WATKIN JONES CONSTRUCTION
Building the future

project no: 12/03	project title: Impact 2, Edward Street SHEFFIELD
drawing no: 006	drawing title: LEVEL 3 PLAN
revision: H	drawn by: / approved by:
date: Sept 2013	scale: 1:100 @ A1
drawing status :	FOR CONSTRUCTION

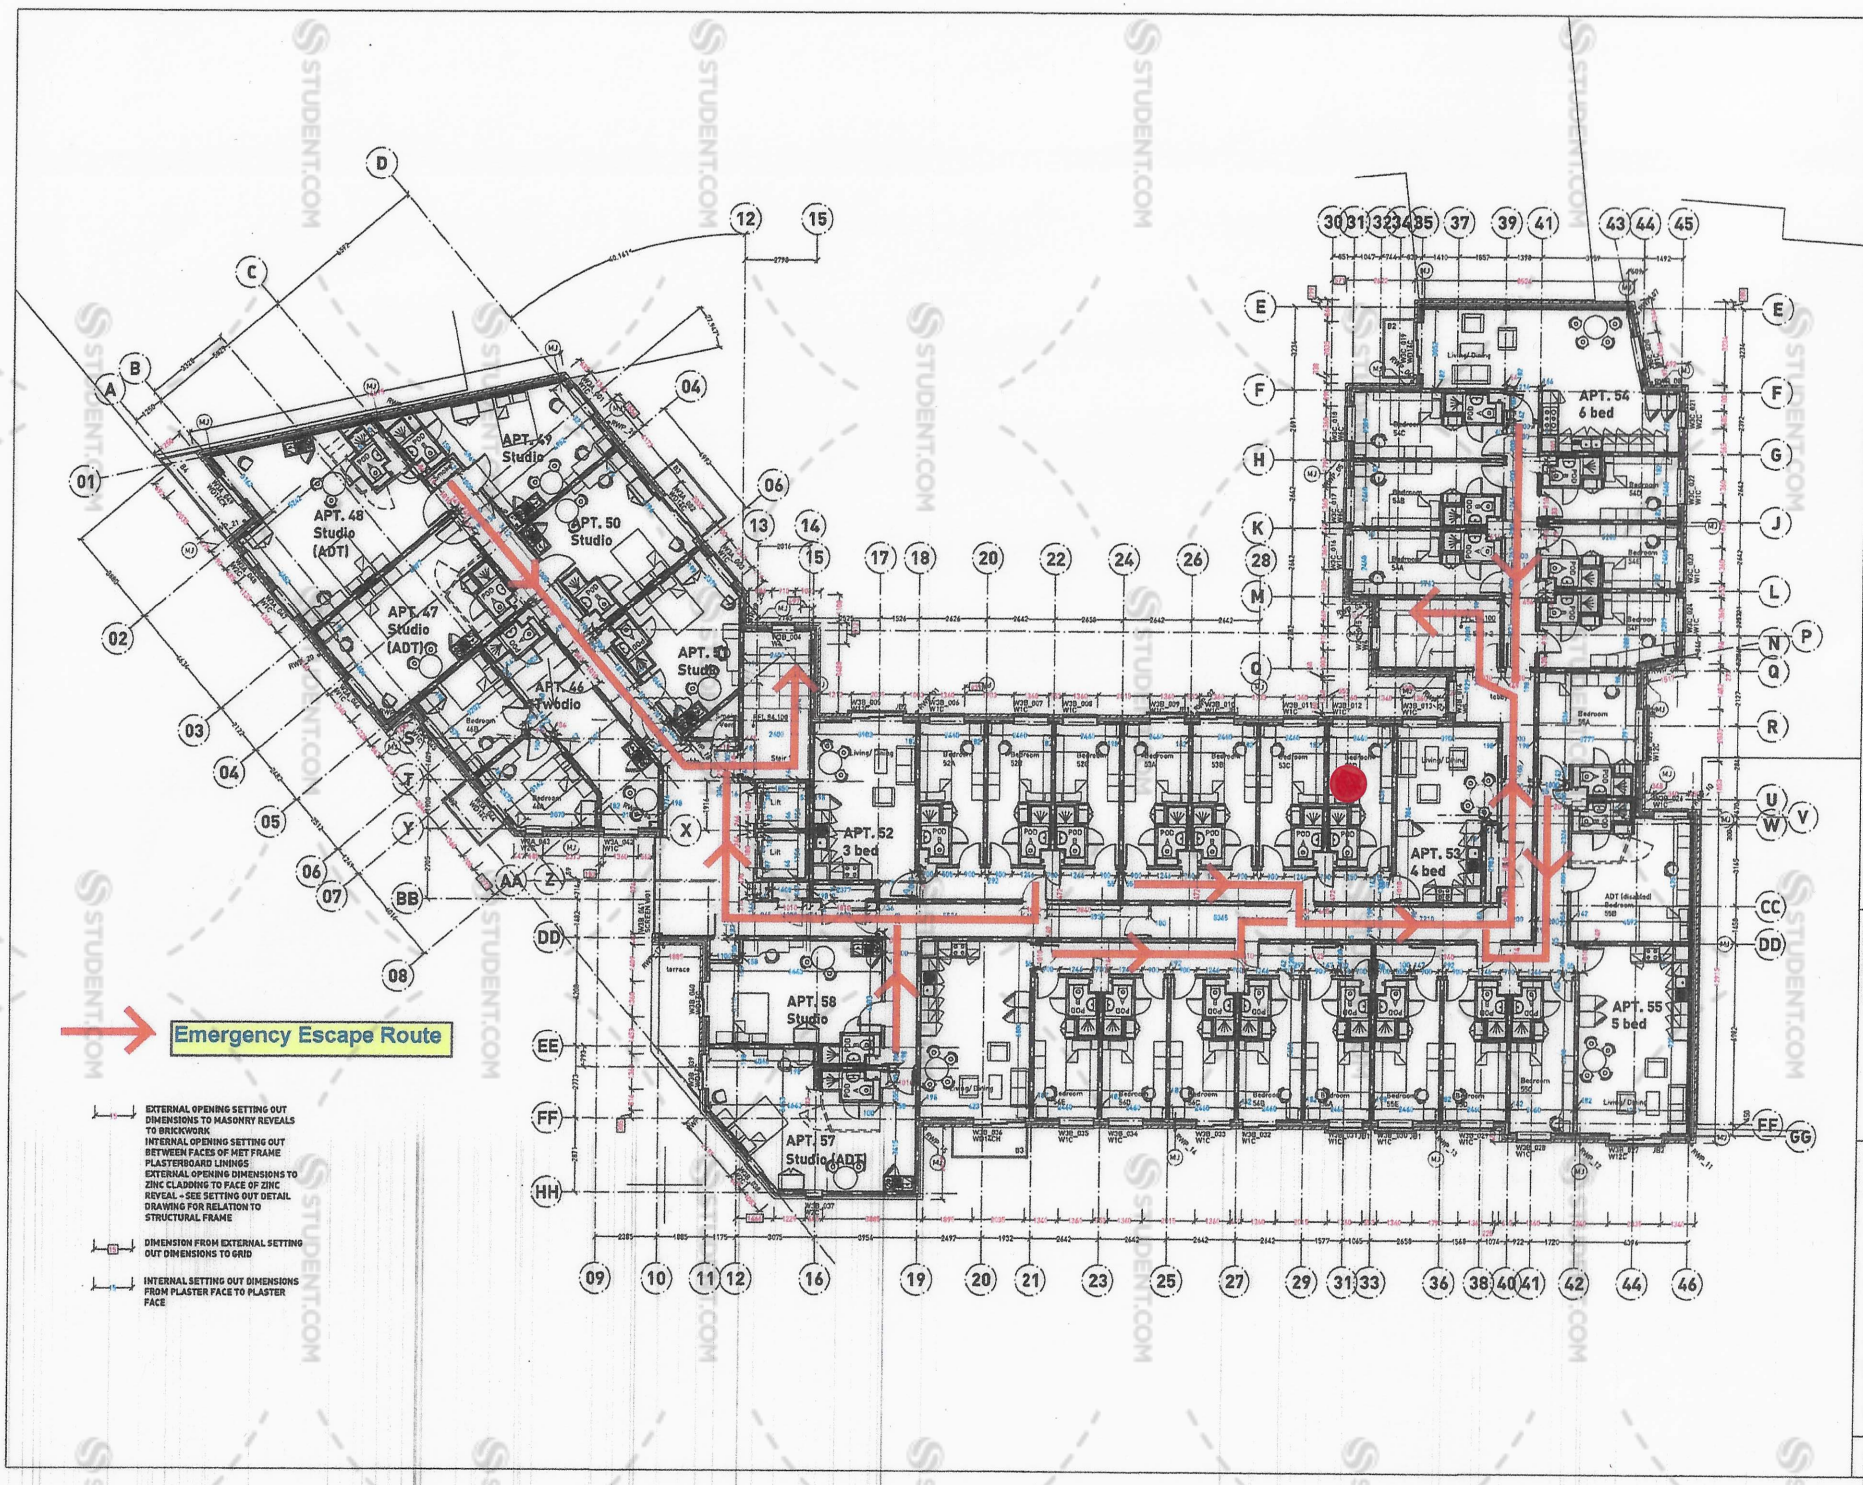
Revision - Date
Rev A - 26/09/13
Internal Structural Opening Setting Out dimensions added, key to dimensions added. Wall - Q41-44 increased to structural 198. Wall - DD142-46 corrected to 182. Grid 17 corrected 100mm towards grid 18. Note regarding resilient bar to 182 walls added
Rev B - 02/10/13
Issued for construction. Staircase 1 rear wall and associated gridline P moved by 530mm to enable staircase walls to align as requested by PAW. External flue riser indicated to coordinate with M&E consultants requirements. Grids 17 & 34 is structural Met Frame. Also wall between Apt 44 and Apt 45/ corridor revised to be structural Met Frame. All as requested by PAW. Dry riser added to Stair 2
Rev C - 08/10/13
Tier columns added, lift openings added, room numbers amended to have letter reference, mobility and ADT (adaptable) rooms amended as instructed, finish floor levels added
Rev D - 1/11/13
Narrow pod riser doors revised to 700mm & external flue enclosure removed as instructed by contractor, position of hat landing window to stair 1 & nrp25 revised, dry riser outlet box dims indicated, balcony references & communal cupboard to lift lobby added.

Rev E - 25/01/14
Cross corridor door to block A omitted,block B cross corridor walls revised to 100mm thk.all as required by fire consultant. Window referencing added.
Rev F - 06/03/14
Smoke vent added to Block A as required by B Control,Apt 48 pod access door relocated,Apt 48 disabled bathroom repositioned, kitchen & studio layouts indicated, window W3A_047 & adjacent brick pier revised to LPA requirement,dimension to gridline F corrected,additional plaster face dims added to M.B partitions
Rev G - 28/04/14
Window W3A_048 to Apt 48 & adjacent brick pier revised to LPA requirement.
Rev H - 18/06/14
Door swings revised to stair 1 and block A corridor to enable mechanical venting to block A smoke shaft
